# Product / Process Change Notification

N° PCN 2018-034-A

## Pin 1 Orientation change to comply with EIA-481 for PG-WSON-8

## ► Detailed Change Information:

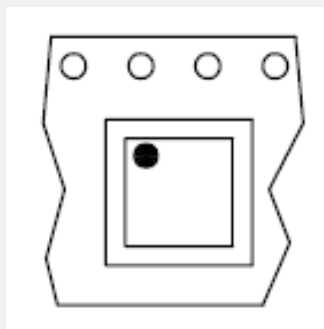
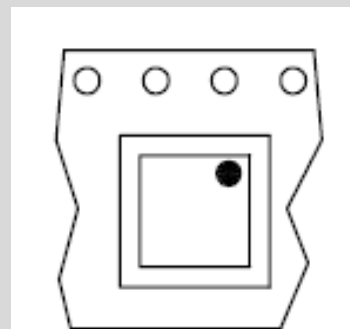
Pin 1 Orientation change from upper left to upper right to comply with industrial (EIA-481) standard for PG-WSON-8 package.

To comply with industrial (EIA-481) packing standard.

■ Pin 1 at Upper Left

■ Pin 1 at Upper Right

No impact on electrical performance of the products as only the packing of the products will be changed. However, there may be a potential orientation adaption needed for automated pick and place manufacturing.
